# MISSISSIPPI POWER & LIGHT COMPANY

SUBJECT: Grand Gulf Nuclear Station  
Unit 1  
Docket No. 50-416  
License No. NPF-13  
File 0260/0840/L-860.0  
Proposed Amendment to the  
Operating License  
(PCOL's-84/09, 13C, and  
14B)  
AECM-84/0318

The description of, technical justification for, and safety evaluation of the proposed changes to the Grand Gulf Technical Specifications are included in Attachments 1 and 2. Each attachment contains all of the proposed technical specification changes which are within the purview of a single branch of the Office of Nuclear Reactor Regulation. The attachments to this letter and the responsible branches for each are listed below:

Figure 3.1.5-1

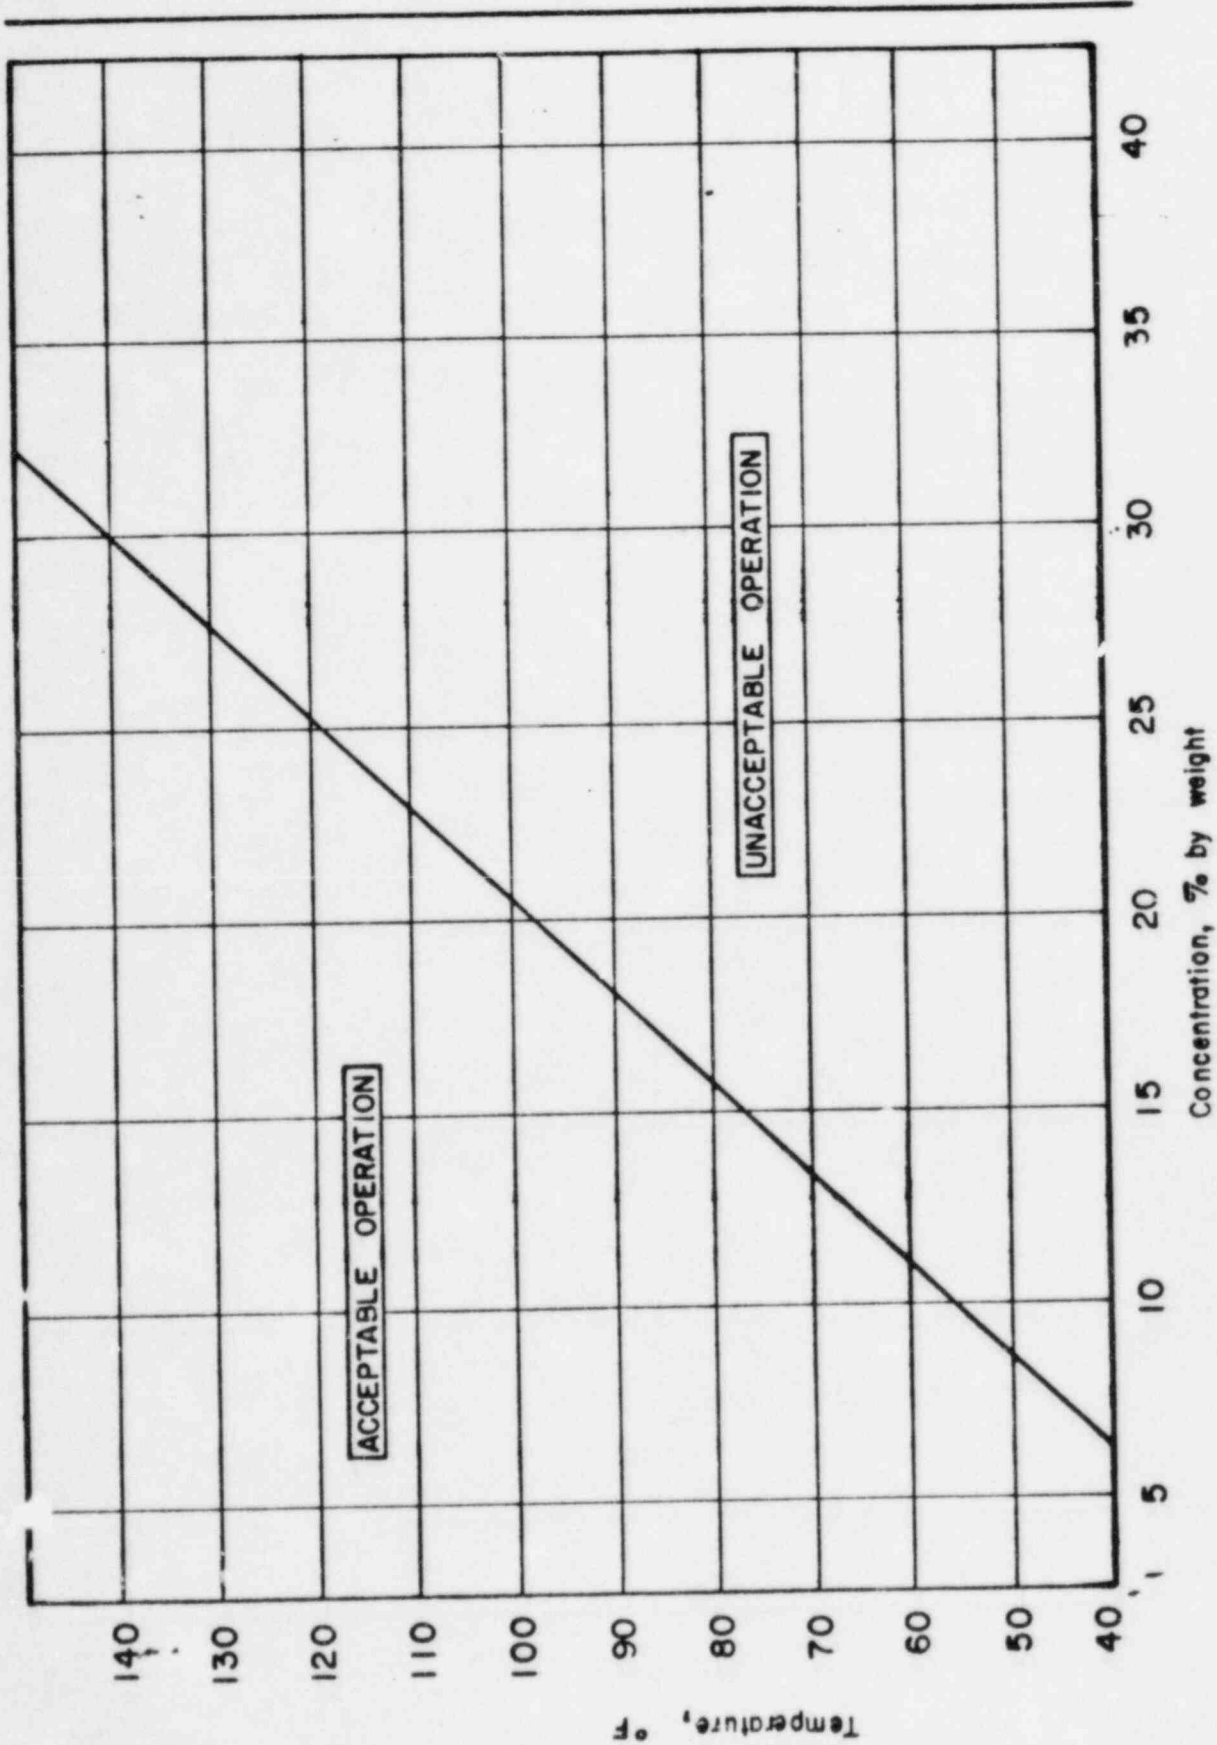
With any control rod ~~withdrawal~~<sup>withdrawn</sup>, when the main turbine bypass valves are not fully closed and THERMAL POWER is greater than the low power setpoint of the RC & IS, immediately return the control rod(s) to the position prior to control rod ~~withdrawal~~. (withdrawal)

Figure 3.2.1-1

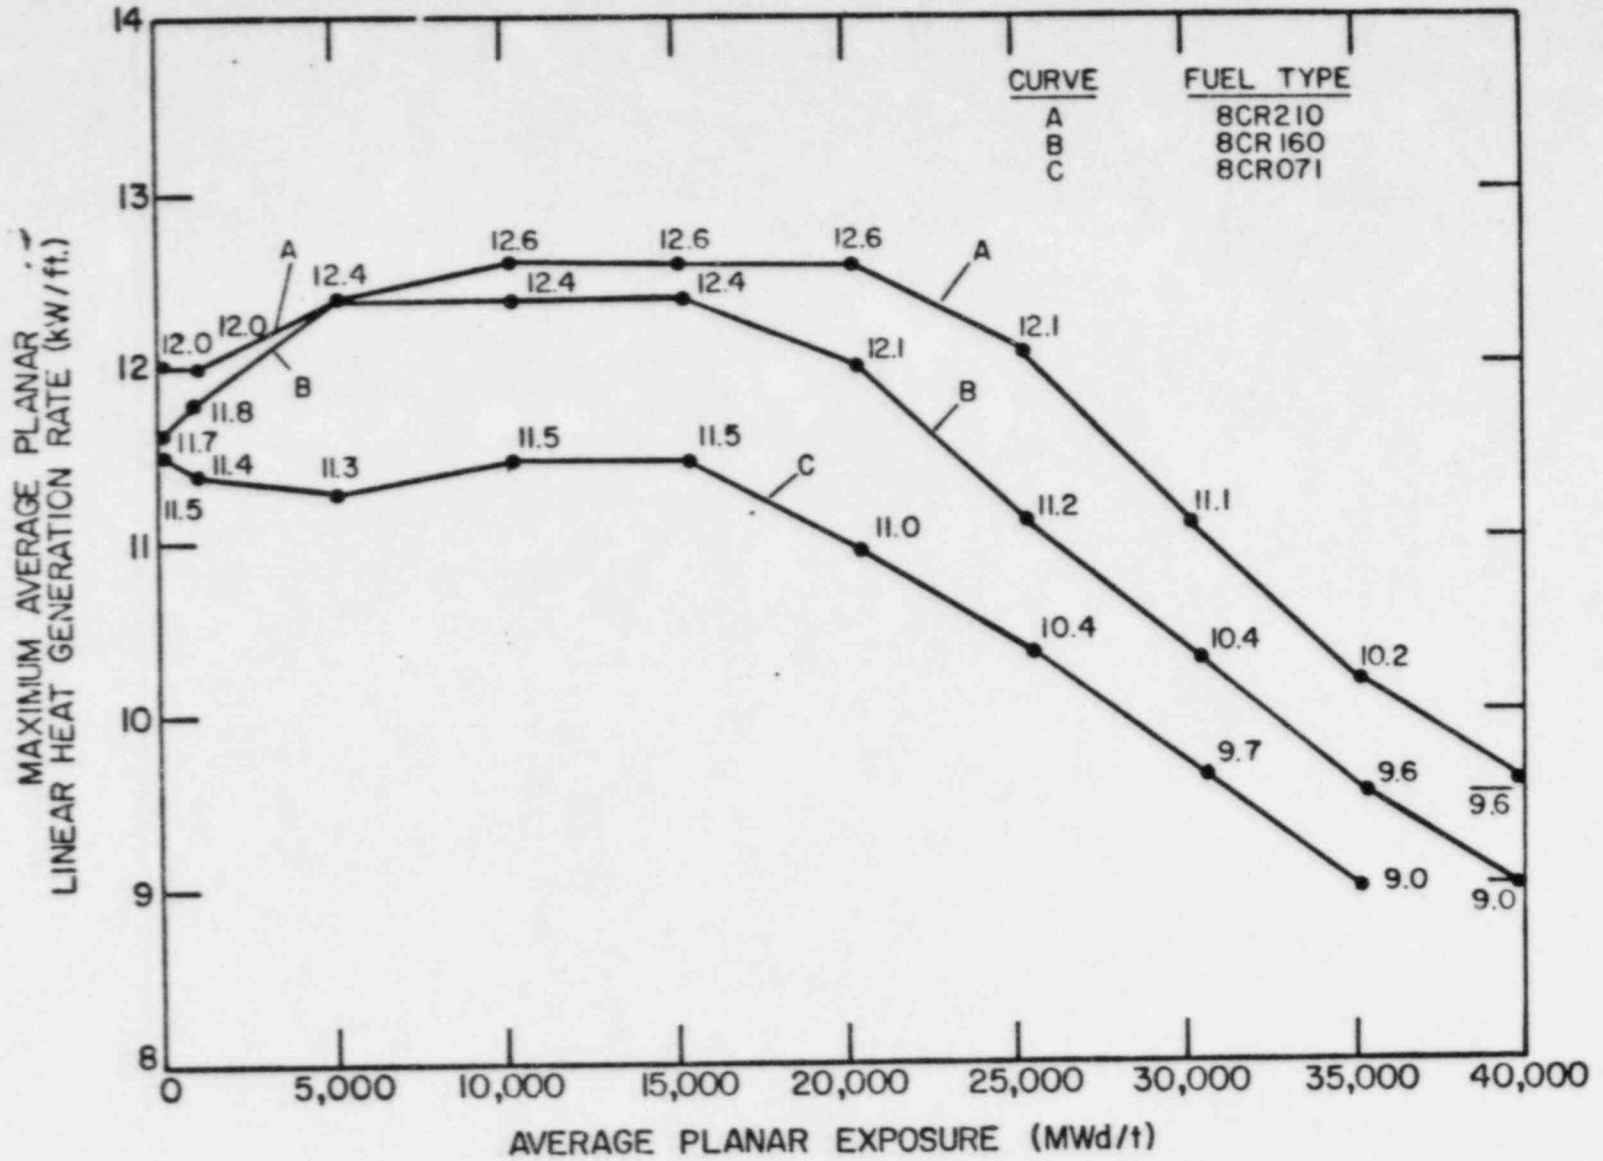
Legible copies of the subject figures are submitted to replace the figures currently found in the technical specifications. The subject figures have been redrawn to show only the major chart divisions, to utilize more legible font, and to clearly identify areas of acceptable and unacceptable operation, where applicable. The MAPLHGR graphs for the three anticipated fuel types (Figures 3.2.1-1, 3.2.1-2, and 3.2.1-3) have been incorporated into a single figure (3.2.1-1). Specification 3/4.2.1 is revised to refer to only this figure. The "75% Rod Line" and the "Maximum Flow Control Line for Transfer to 100% Speed" are added to Figure B 3/4.2.3-1 for enhancement. Neither the limits of operation or scale ranges of the figures are affected by this submittal. This is an administrative change that enhances the readability of the technical specifications, and is submitted in response to NRC requests. (Pages 3/4 1-20, 3/4 2-1, 3/4 2-2, 3/4 2-3, 3/4 2-4, 3/4 2-7, 3/4 2-8, B 3/4 2-5, B 3/4 3-7 and B 3/4 4-7)

Figure B 3/4 2.3-1

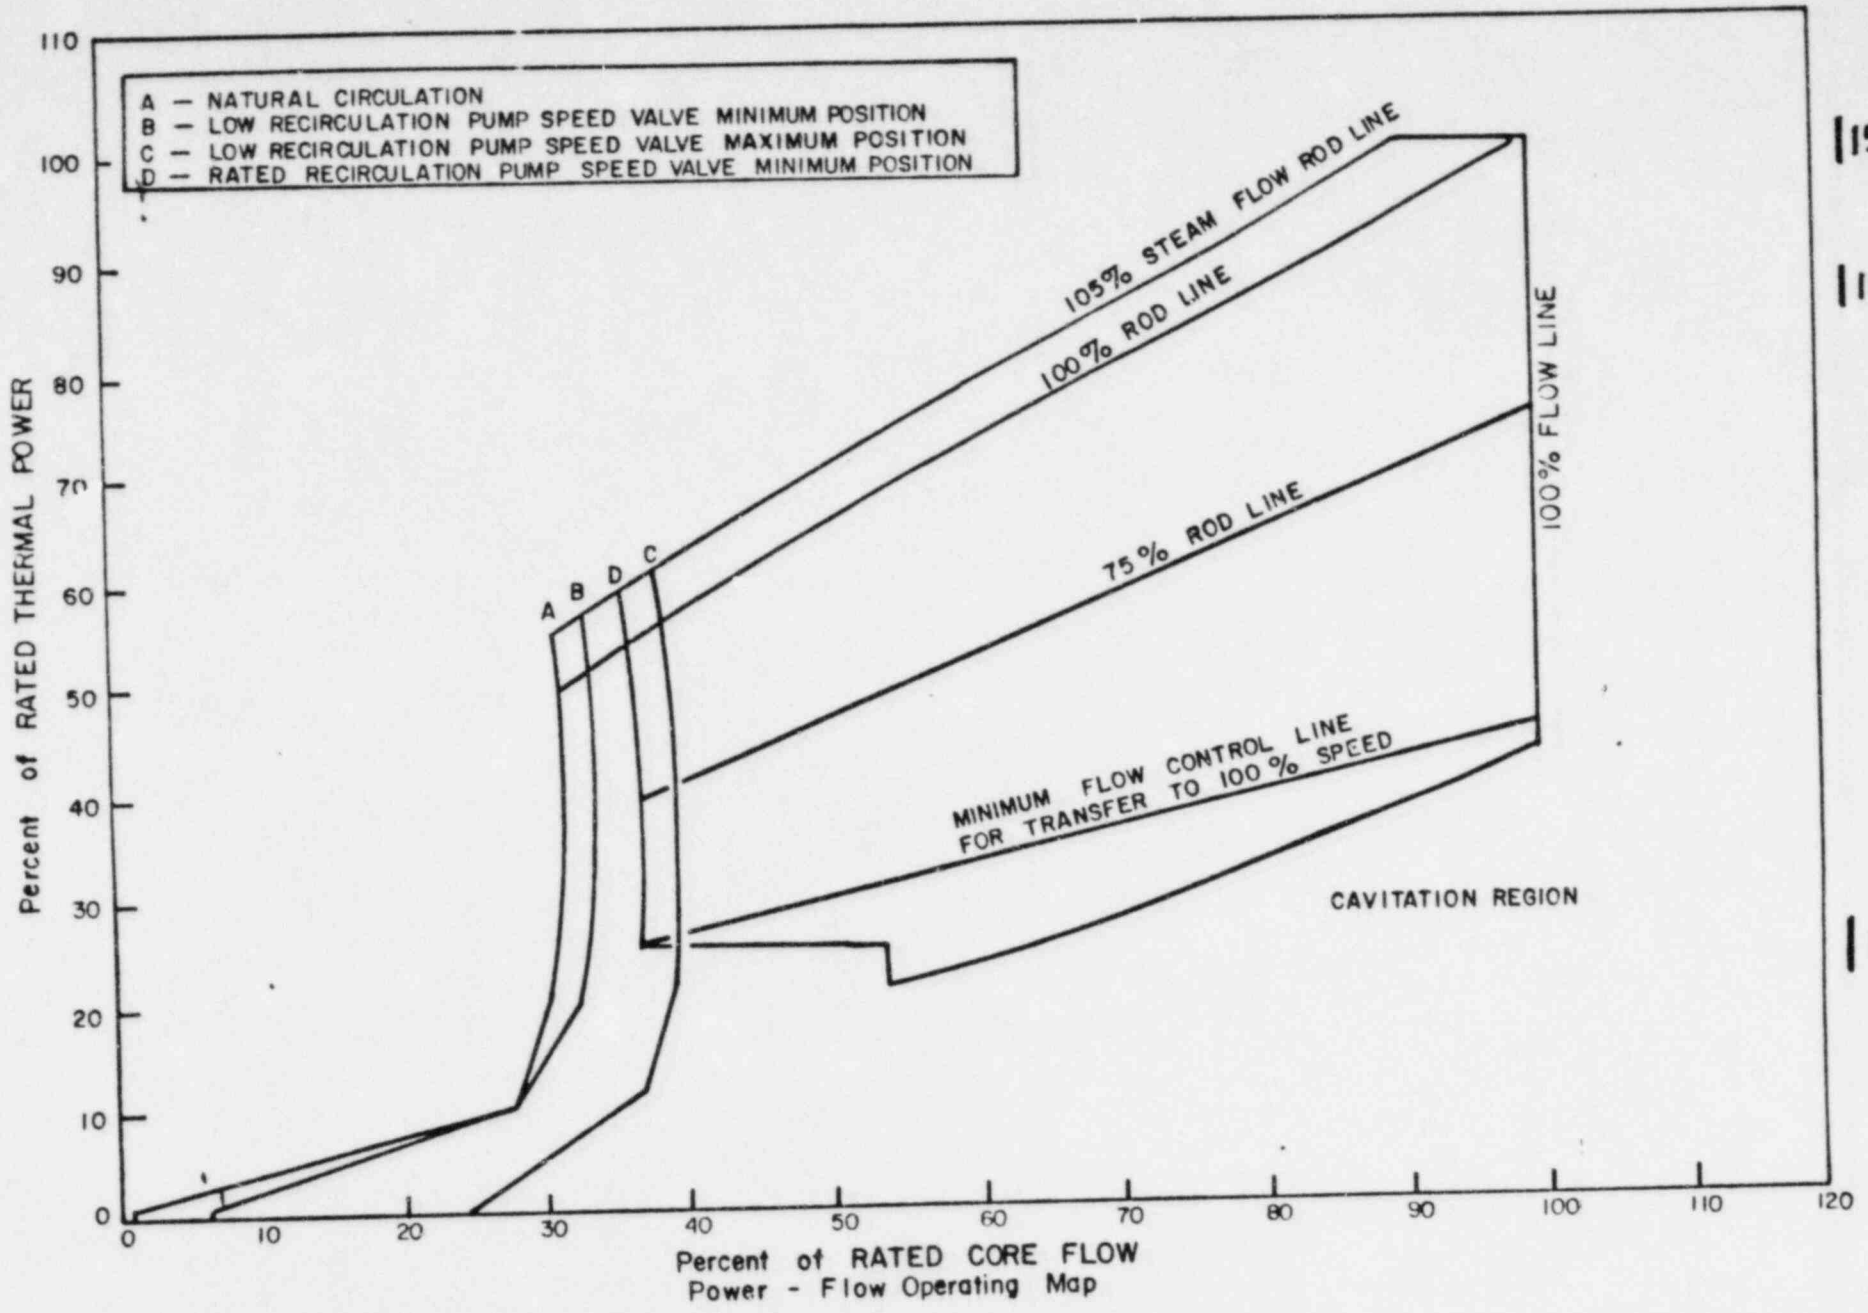
INSERT → The purpose of the MCPR<sub>s</sub> and MCPR<sub>D</sub> of Figures 3.2.3-1 and 3.2.3-2 is to define operating limits at other than rated core flow and power conditions. At less than 100% of rated flow and power the required MCPR is the larger value of the MCPR<sub>s</sub> and MCPR<sub>D</sub> at the existing core flow and power state. The MCPR<sub>s</sub> are established to protect the core from inadvertent core flow increases such that the 99.9% MCPR limit requirement can be assured.

~~The MCPR<sub>s</sub> were calculated such that for the maximum core flow rate and the corresponding THERMAL POWER along the 105% of rated steam flow control line, the limiting bundle's relative power was adjusted until the MCPR was slightly above the Safety Limit. Using this relative bundle power, the MCPRs were calculated at different points along the 105% of rated steam flow control line corresponding to different core flows. The calculated MCPR at a given point of core flow is defined as MCPR<sub>s</sub>.~~

~~The MCPR<sub>s</sub> are established to protect the core from plant transients other than core flow increases, including the localized event such as rod withdrawal error. The MCPR<sub>s</sub> were calculated based upon the most limiting transient at the given core power level.~~

The reference core flow increase event used to establish the  $MCPR_f$  is a hypothesized slow flow runout to maximum, that does not result in a scram from neutron flux overshoot exceeding the APRM neutron flux-high level (Table 2.2.1-1 item 2). With this basis the  $MCPR_f$  curve is generated from a series of steady state core thermal hydraulic calculations performed at several core power and flow conditions along the steepest flow control line. This corresponds to the 105% steamflow flow control line (Figure B 3/4 2.3-1). In the actual calculations a conservative highly steep generic representation of the 105% steamflow flow control line has been used. Assumptions used in the original calculations of this generic flow control line were consistent with a slow flow increase transient duration of several minutes: a) the plant heat balance was assumed to be in equilibrium, and b) core xenon concentration was assumed to be constant. The generic flow control line is used to define several core power/flow states at which to perform steady-state core thermal-hydraulic evaluations.

The  $MCPR_f$  is established to protect the core from plant transients other than core flow increase including the localized rod withdrawal error event. Core power dependent setpoints are incorporated (incremental control rod withdrawal limits) in the Rod Withdrawal Limiter (RWL) System Specification (3.3.6). These setpoints allow greater control rod withdrawal at lower core powers where core thermal margins are large. However, the increased rod withdrawal requires higher initial  $MCPR$ 's to assure the  $MCPR$  safety limit Specification (2.1.2) is not violated. The analyses that establishes the power dependent  $MCPR$  requirements that support the RWL system are presented in GESSAR II, Appendix 15B. Since the severity of other (core-wide) transients at off-rated conditions is limited by the requirement to setdown the APRM flow biased simulated thermal power-high scram trip setpoint, Specification (3.2.2), the rod withdrawal error is the limiting transient and establishes  $MCPR_p$  requirements.

Insert for 3/4.3.7.10, Page B 3/4 3-5

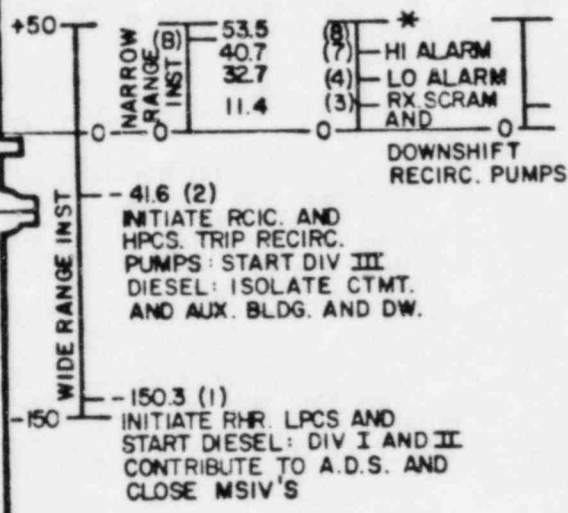
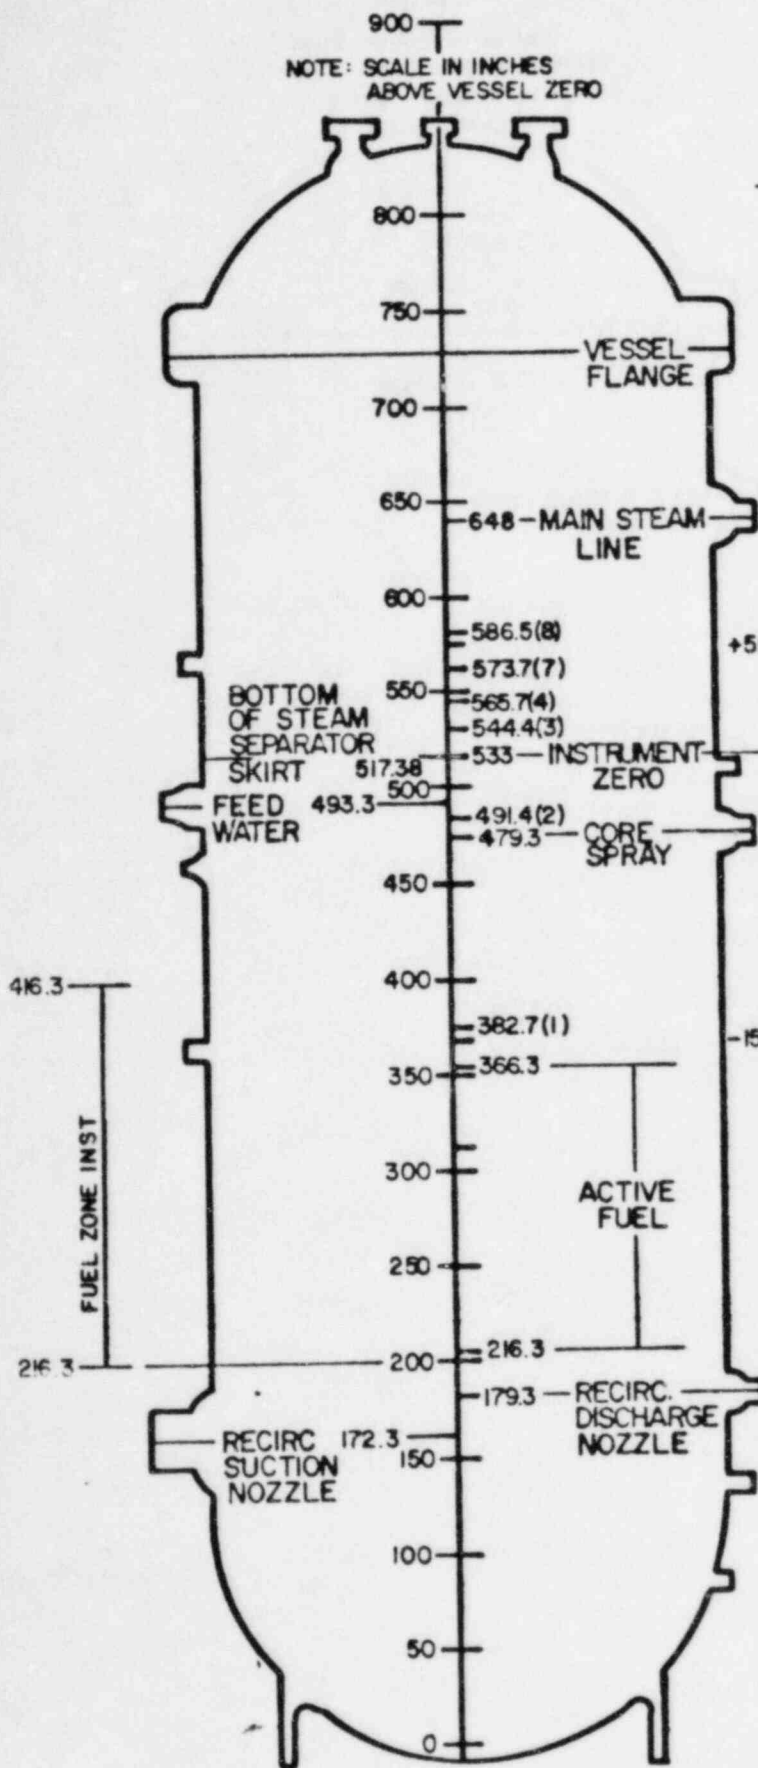
The proposed change adds additional information to the loose-part detection system bases. The loose-part detection system consists of eight channels comprised of sixteen sensors of which eight sensors are active to provide alarm and indication functions. The remaining eight sensors are passive at similar locations that are available for use if an active sensor fails. These passive sensors can be interchanged with the active sensors by swapping the individual connectors at the loose-part monitor panel located in the lower cable spreading room. A change to Bases 3/4.3.7.10 is proposed to distinguish between active and passive sensors. This proposed change is an enhancement and does not adversely impact plant safety because it is consistent with the safety analyses and the licensing basis. (Page B 3/4 3-5)

The system consists of 16 sensors, of which only 8 are selected and need to be OPERABLE at a time, to provide the inputs to the 8 monitoring channels. The remaining 8 sensors may be used as replacement sensor inputs for failed sensors or to provide a change in location of the area being monitored.
